ADDENDUM NO. 2

**Three Rivers Community Schools – Three Rivers Middle School Additions and
Renovation**

SHEET CLARIFICATIONS / REVISIONS

UNIT 'E' FIRST FLOOR POWER & COMMUNICATIONS PLAN
1/8" = 1'-0"

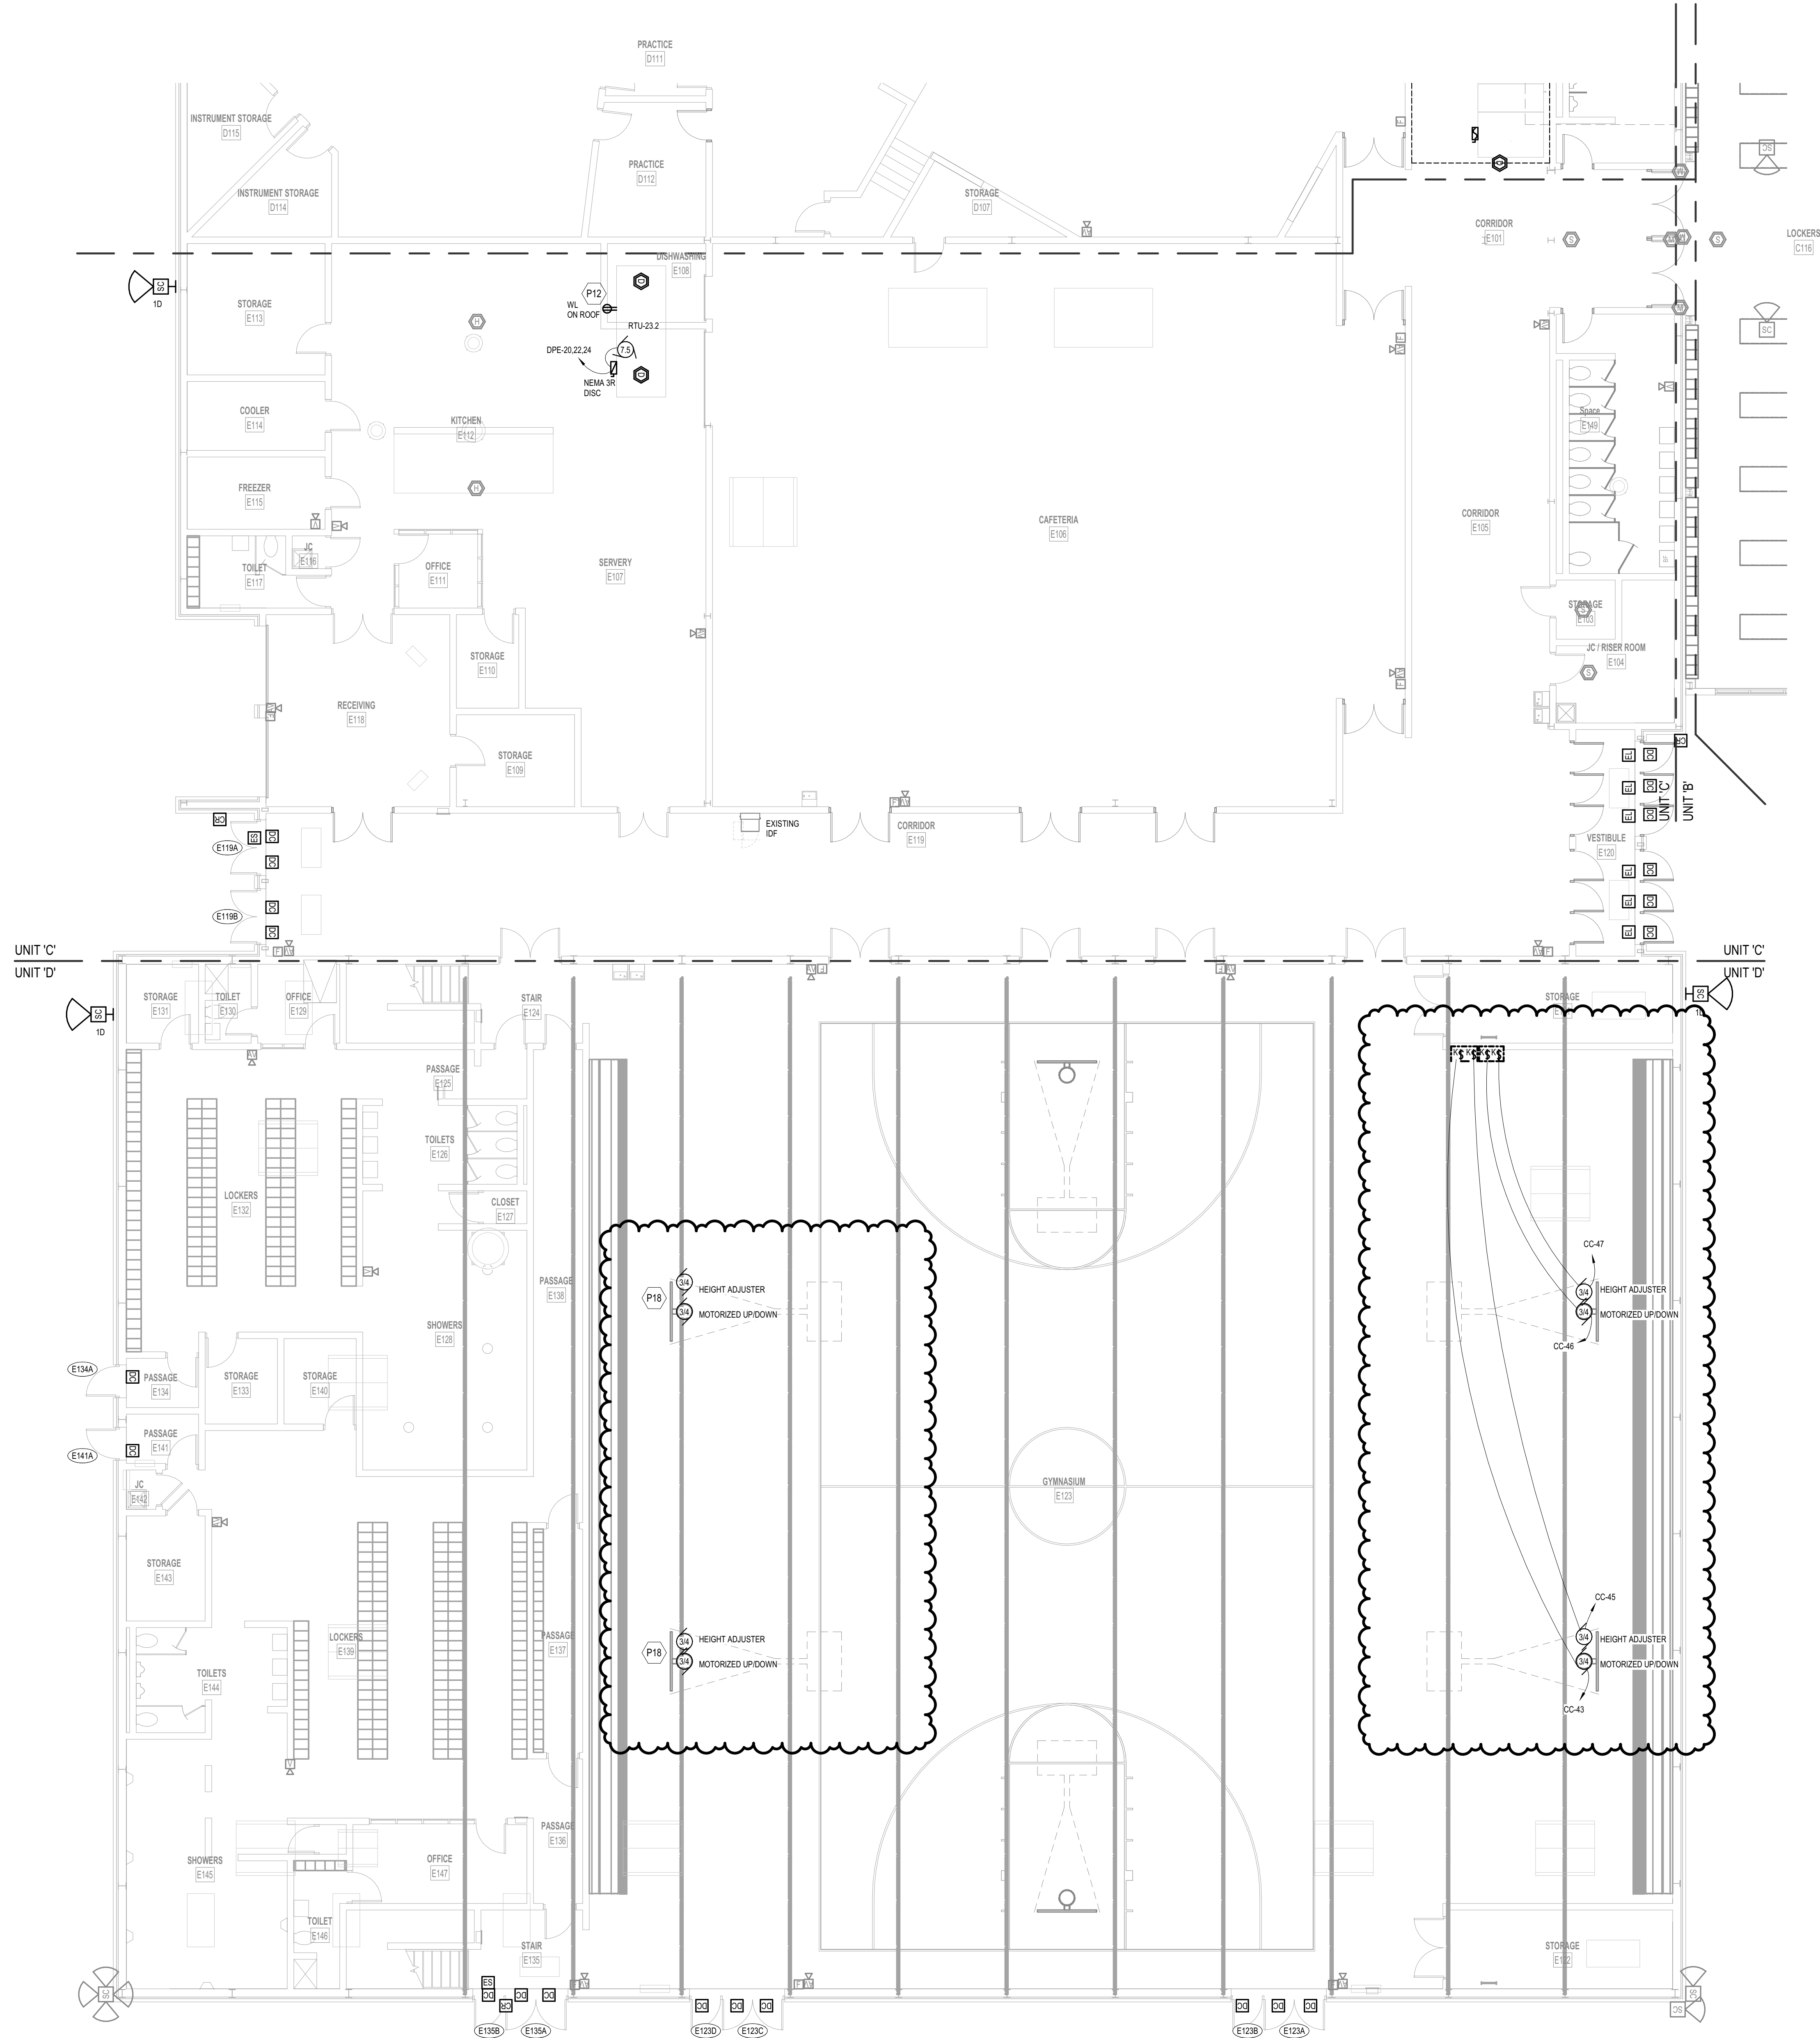
ITEM NO. 57 SHEET E2.1E UNIT 'E' FIRST FLOOR POWER & COMMUNICATIONS PLAN (REISSUED)

Refer to the plan for the added (2) basketball hoops and the reconnection of the two replaced hoops.

SITE ELECTRICAL PLAN

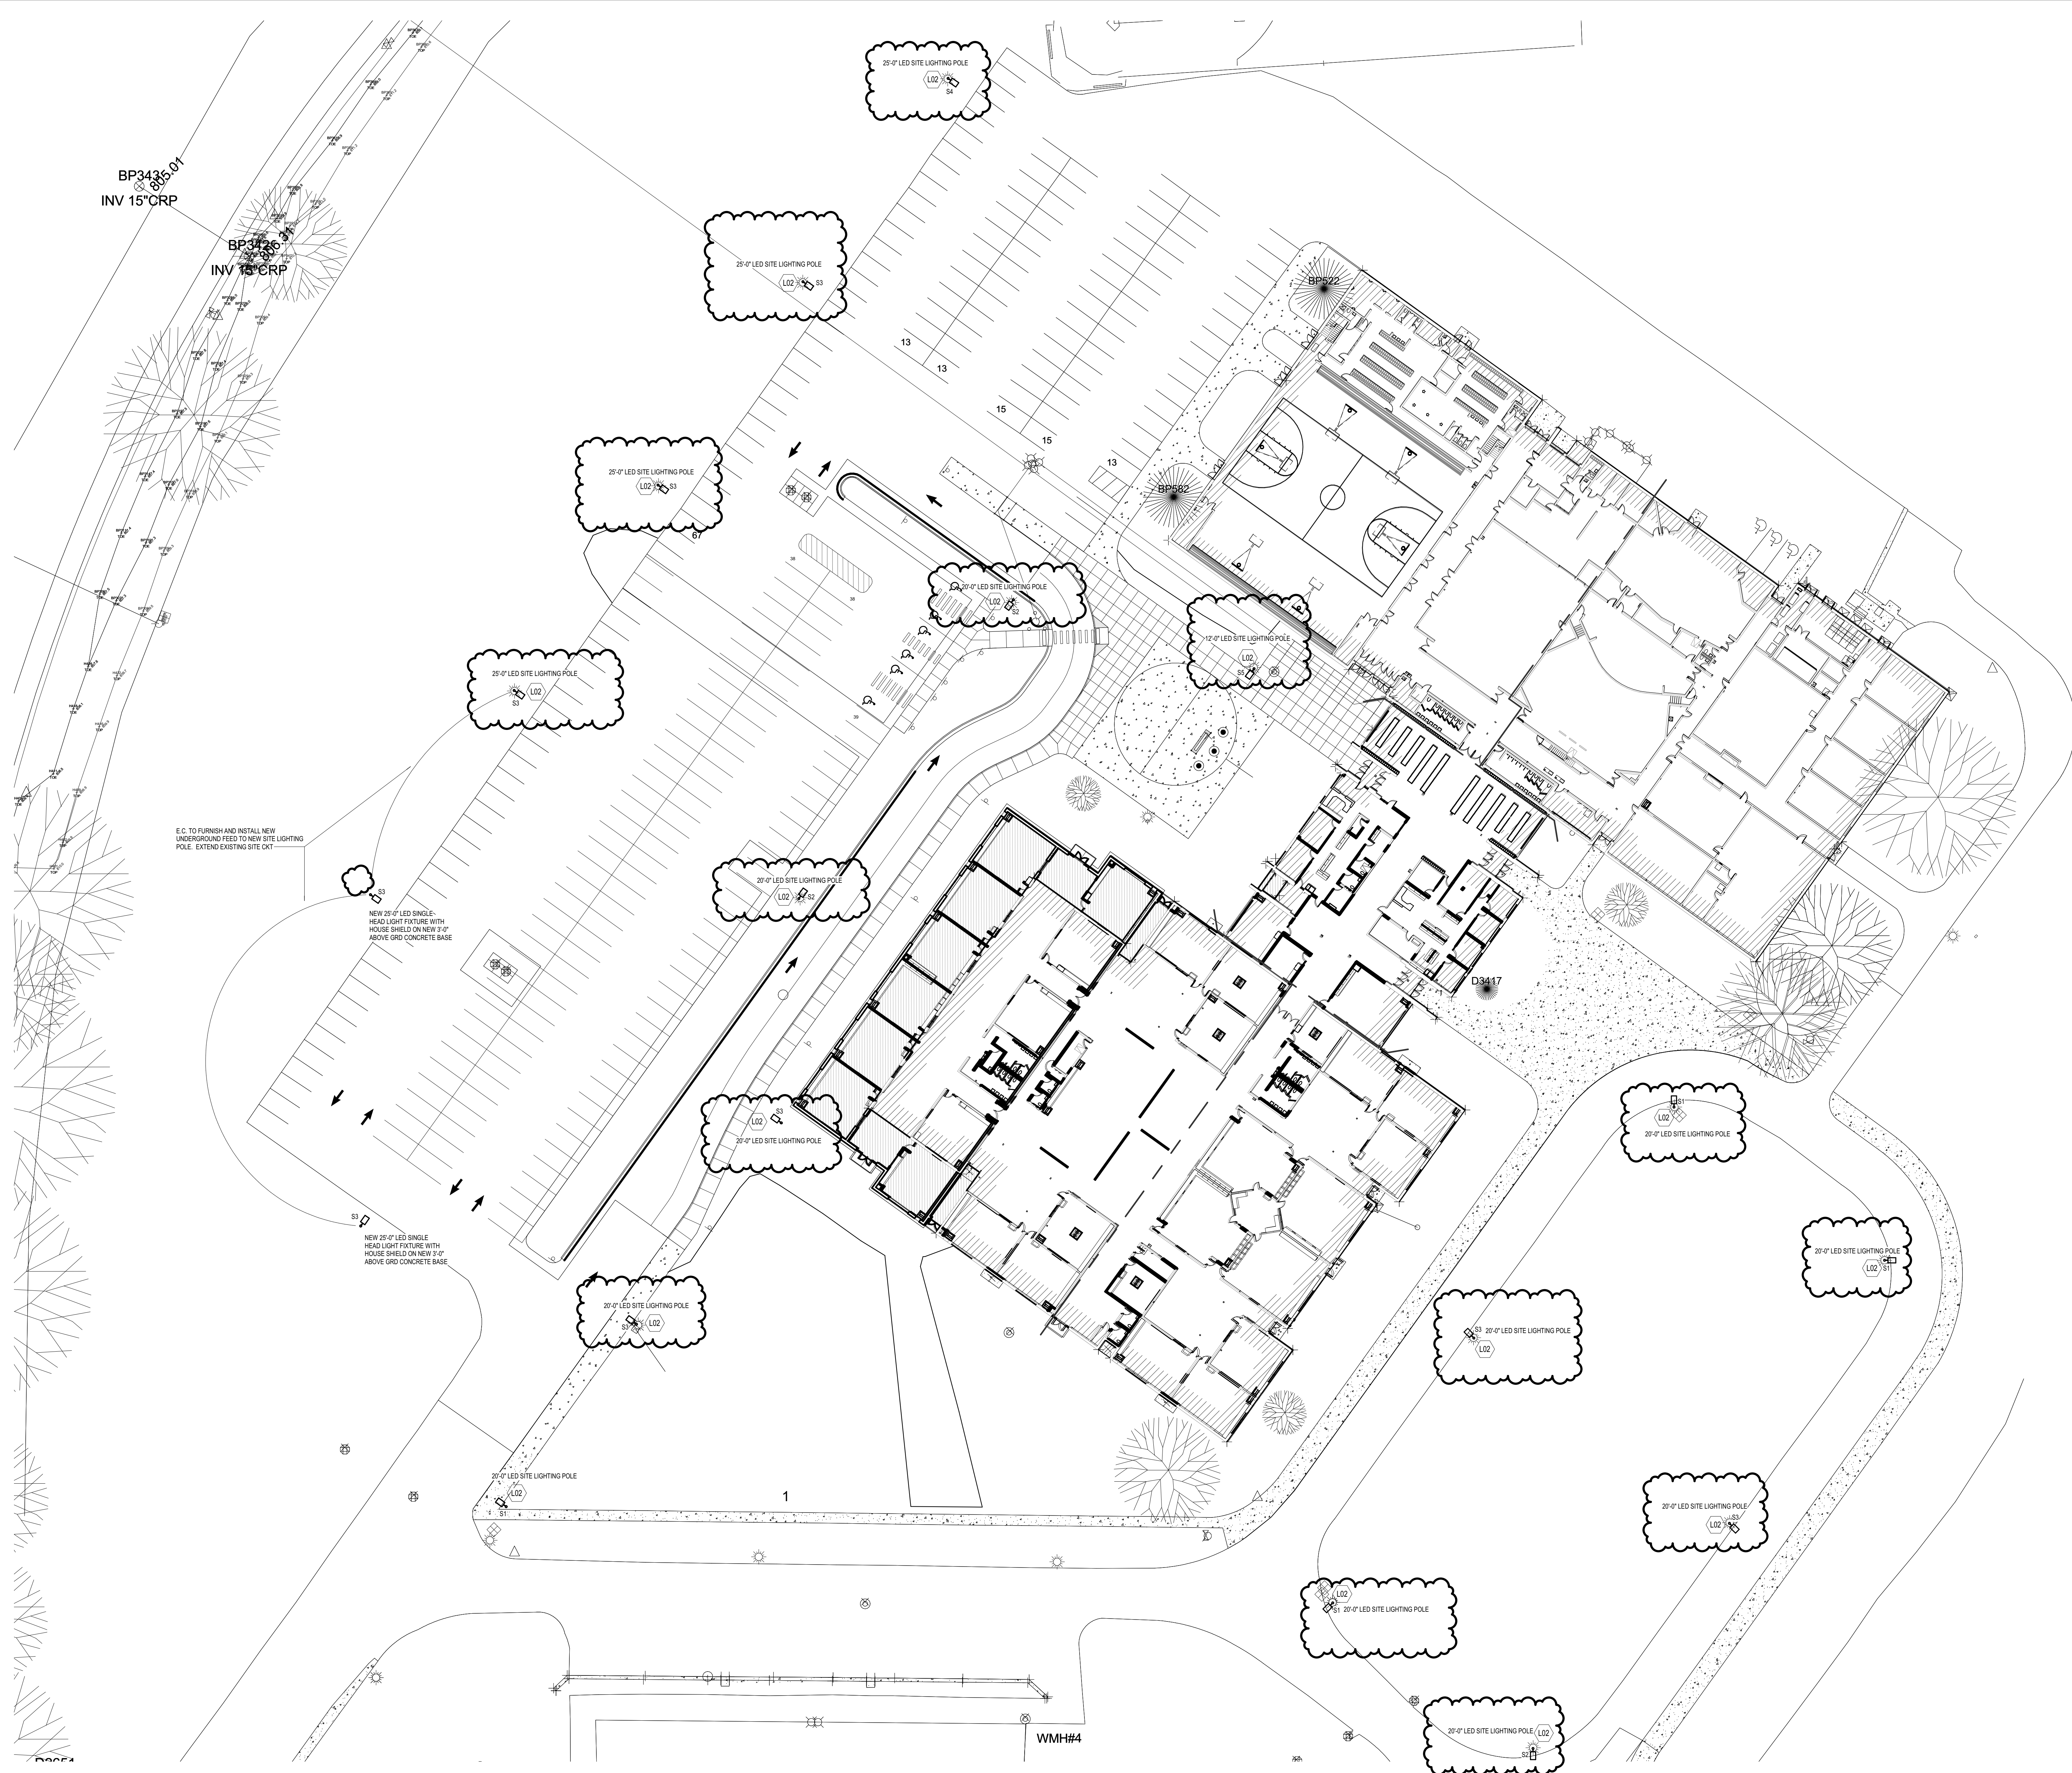
ITEM NO. 62 SHEET ES2.01 SITE ELECTRICAL PLAN (REISSUED)

Refer to the plan for the notes to be removed from existing site lighting poles. All existing site lighting poles as per Keynote L02 are to reuse existing concrete bases and underground feeders.
